Design Note

Project: Field House

File ref: NOTE-1013359-5A-LR-20210811-Facade requirements note-Rev00

Façade sound insulation requirements.

Planning stage minimum glazing sound insulation requirements.

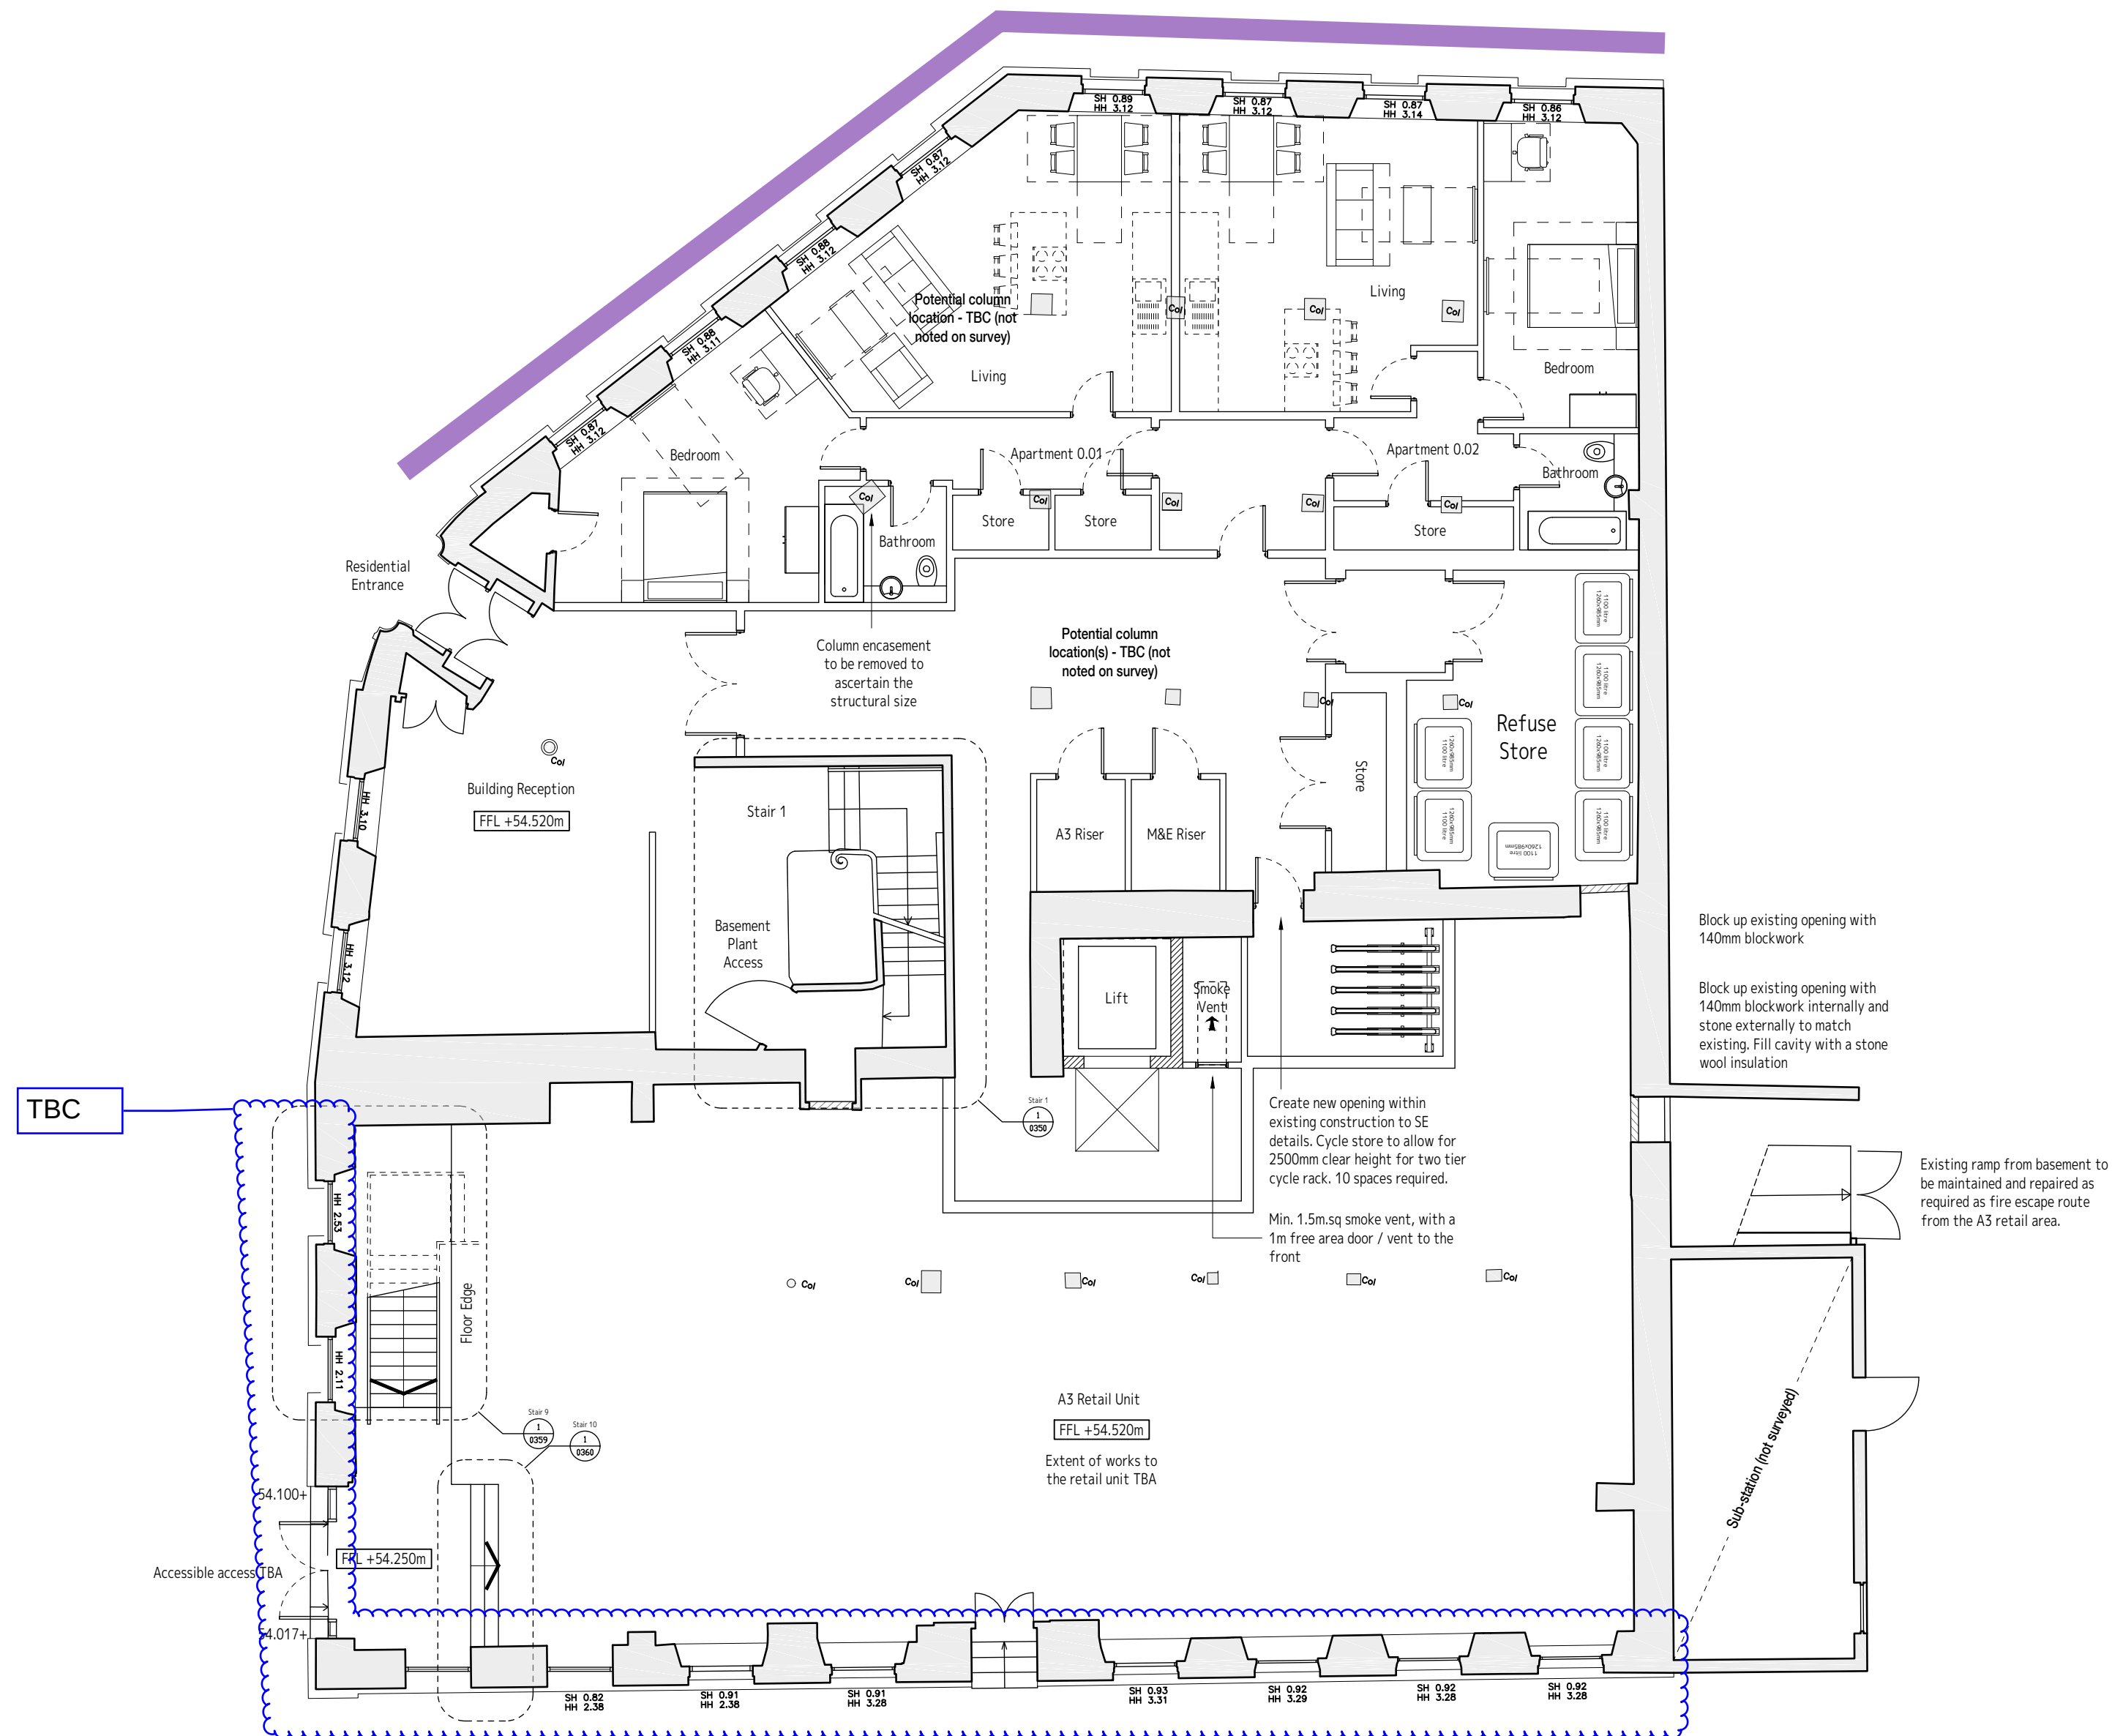
Minimum $R_w + C_{tr}$ 34 dB glazing

Minimum $R_w + C_{tr}$ 27 dB glazing

TITLE
Proposed First Floor Plan

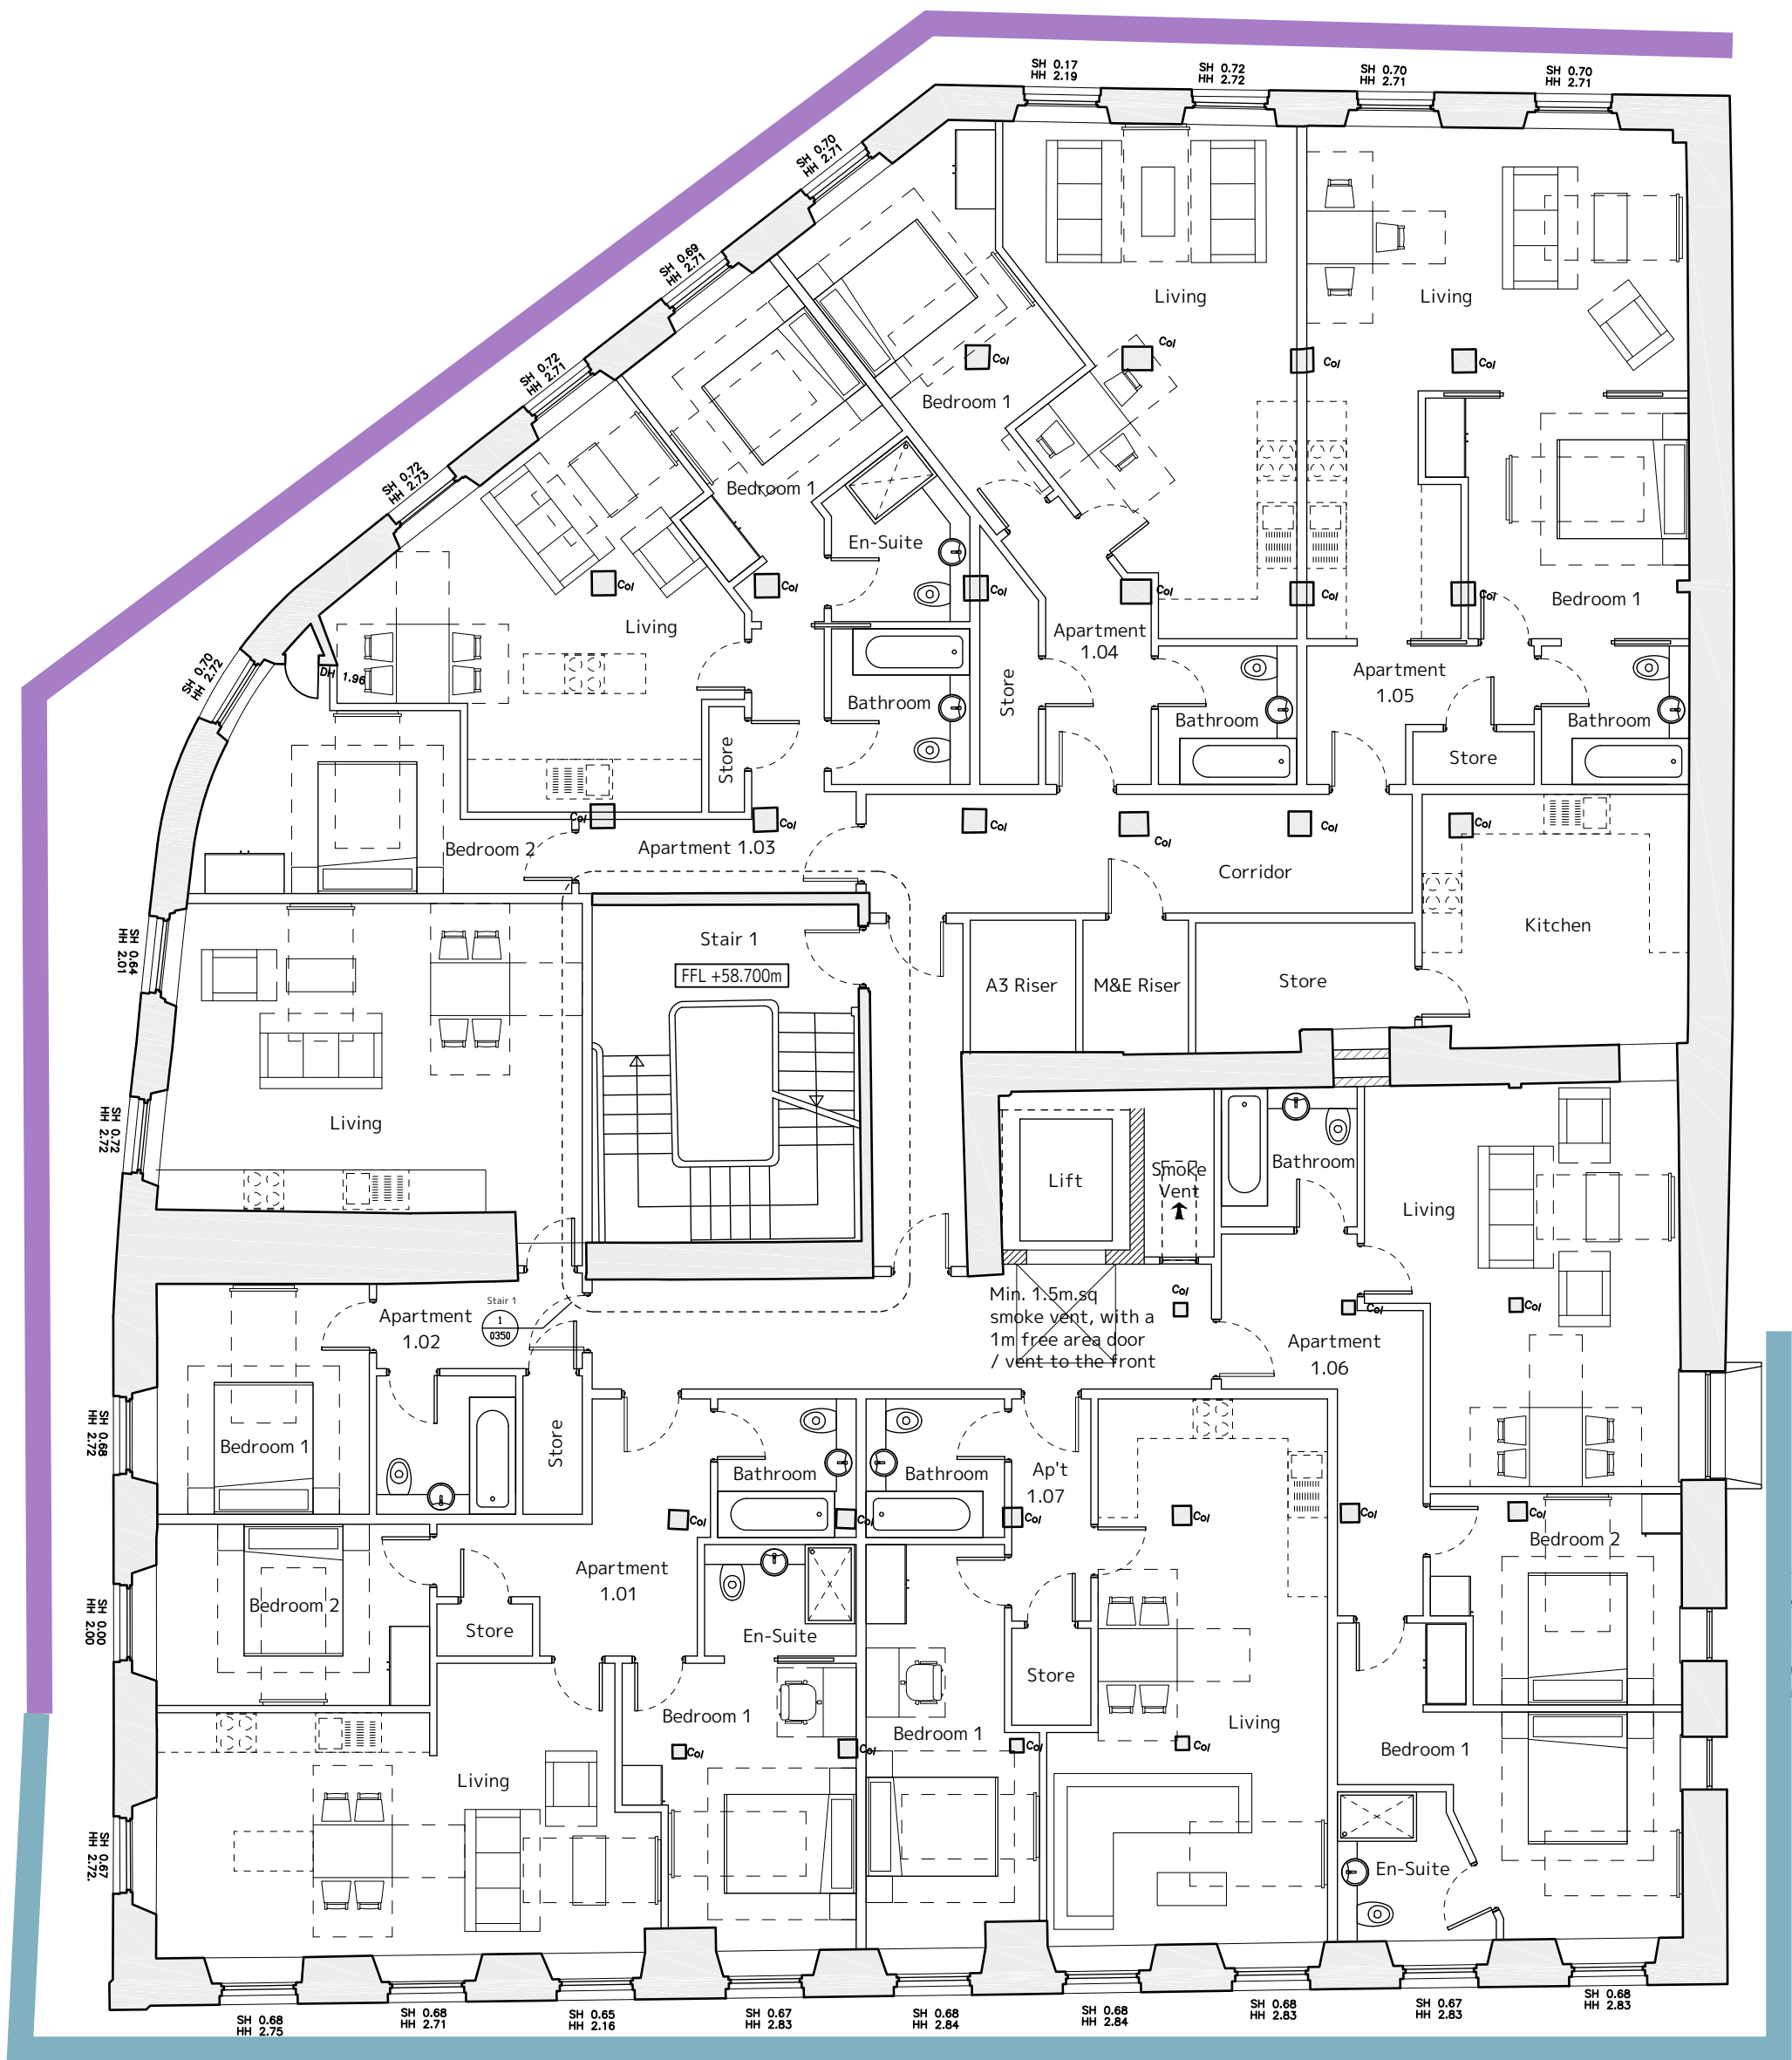
Minimum R_w+C_{tr} 34 dB glazing

Minimum R_w+C_{tr} 27 dB glazing

TITLE
Proposed Third Floor Plan

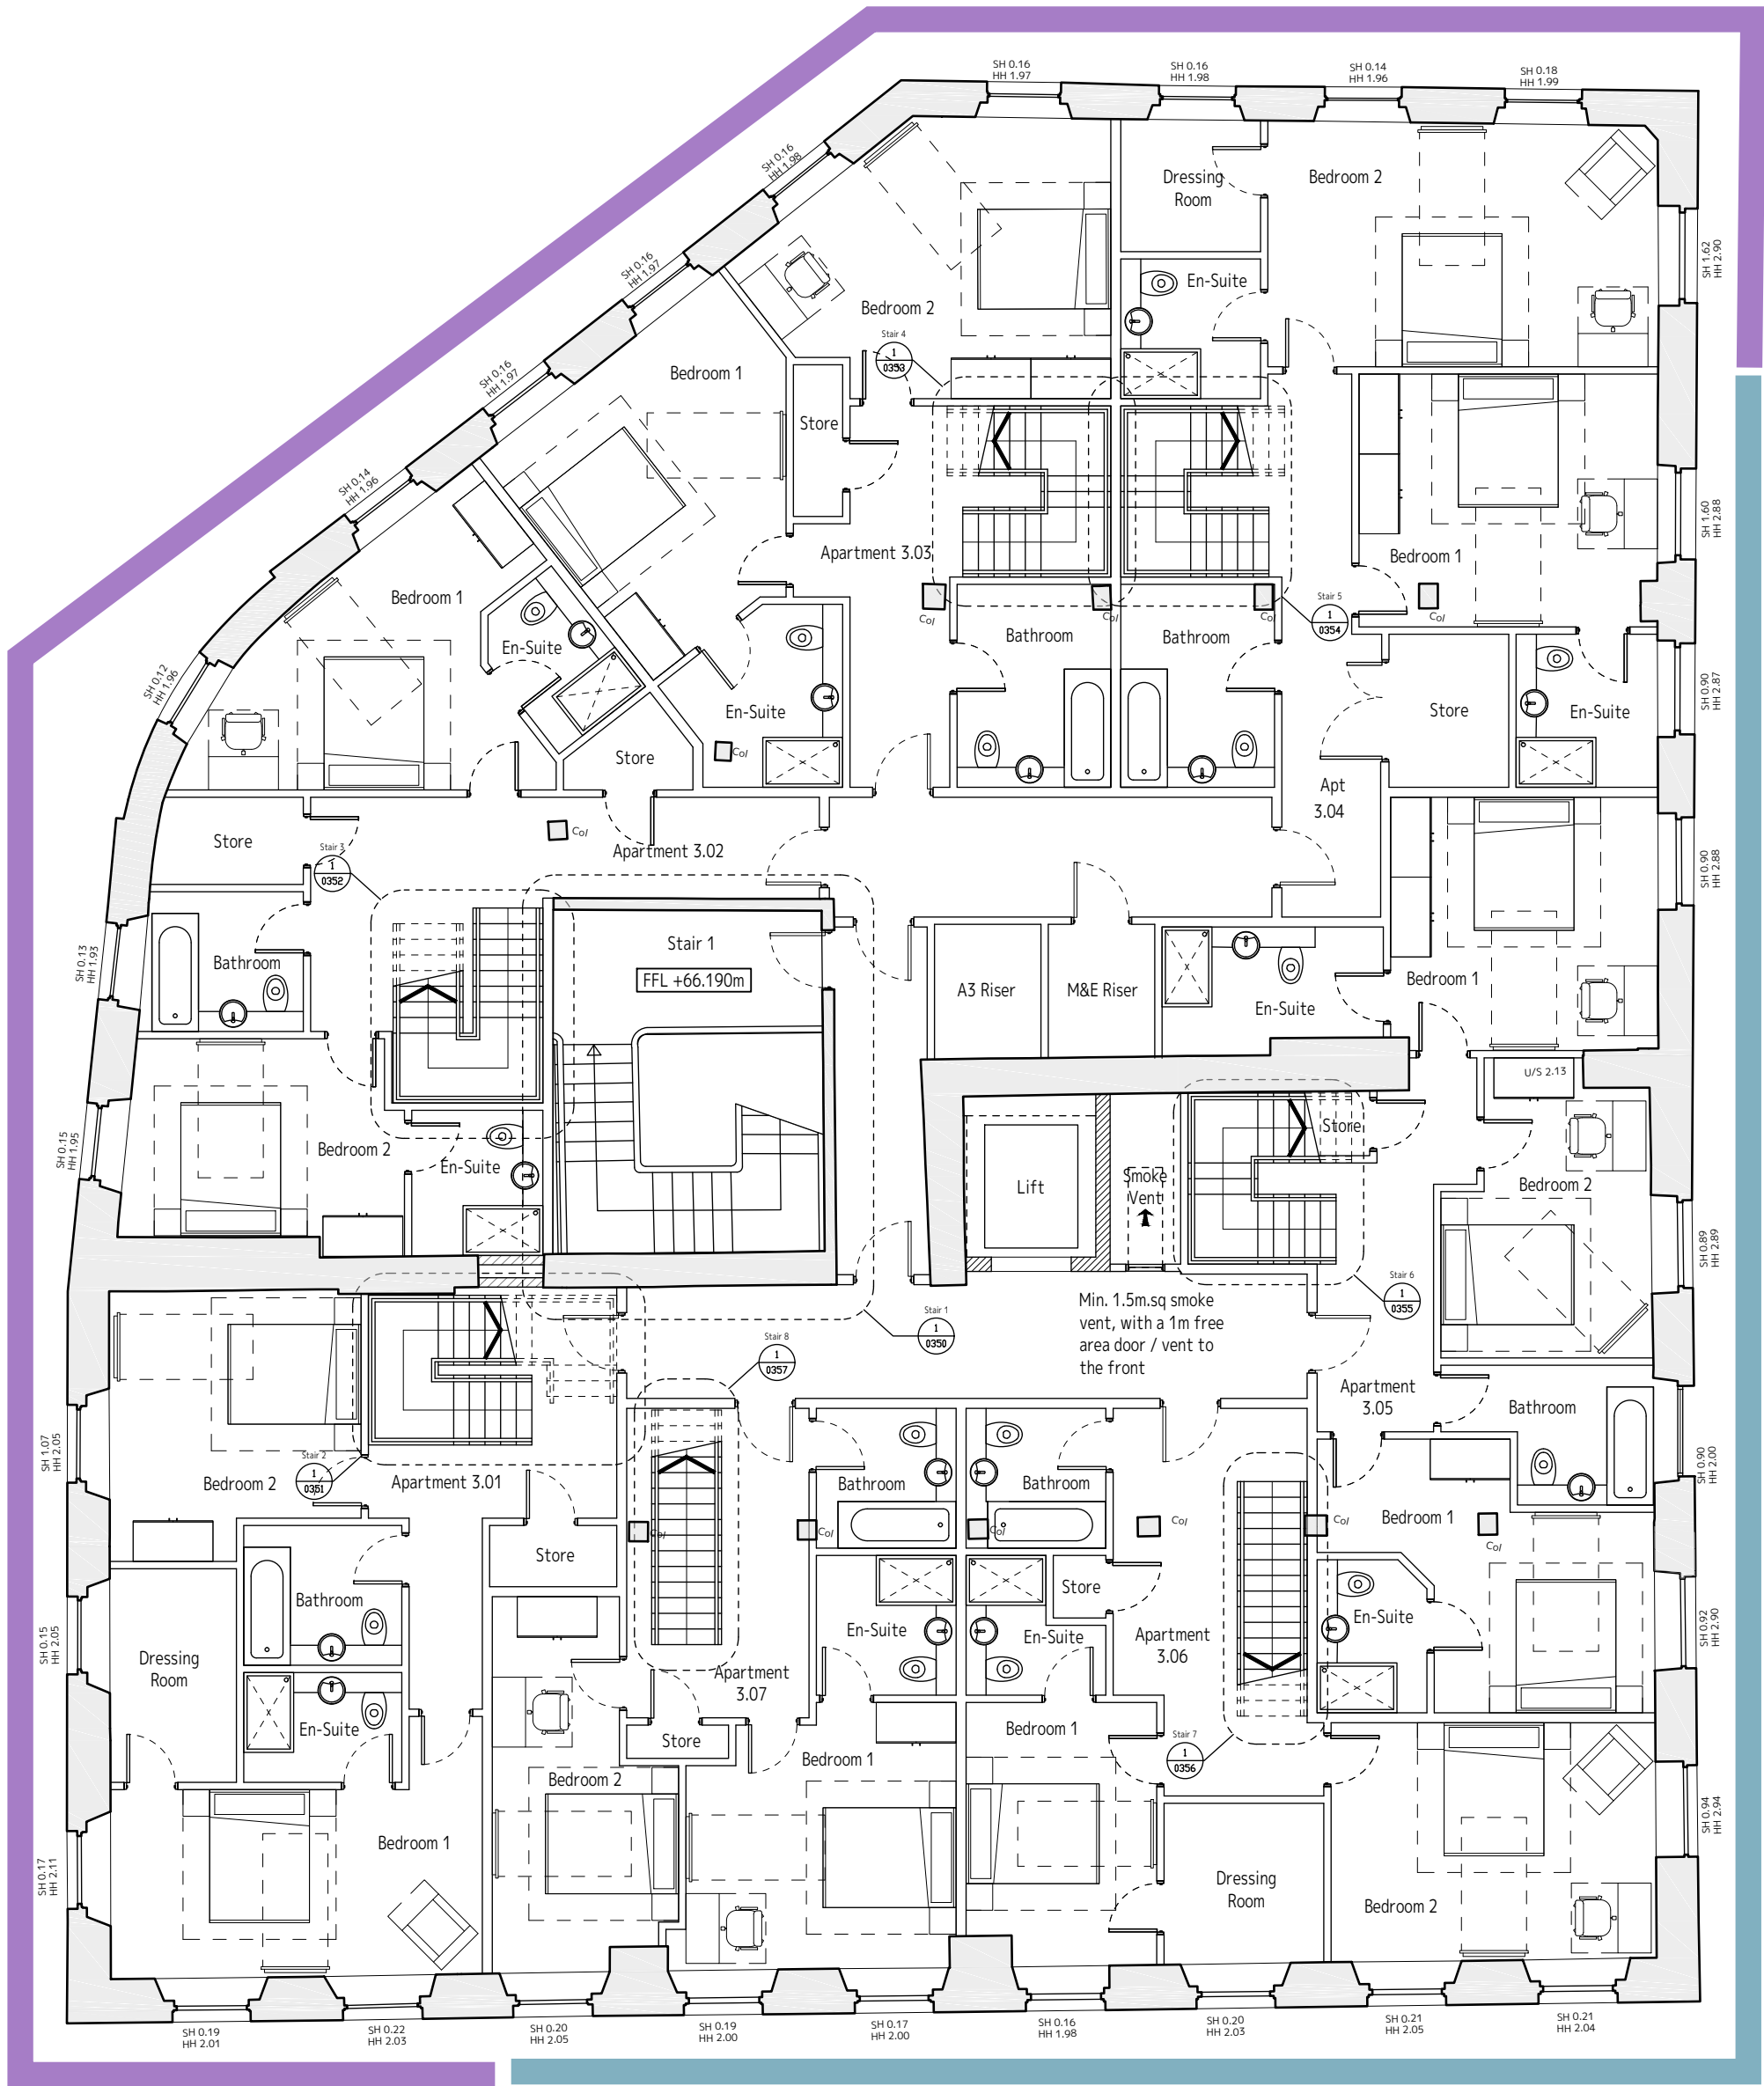
Minimum R_w+C_{tr} 34 dB glazing

Minimum R_w+C_{tr} 27 dB glazing
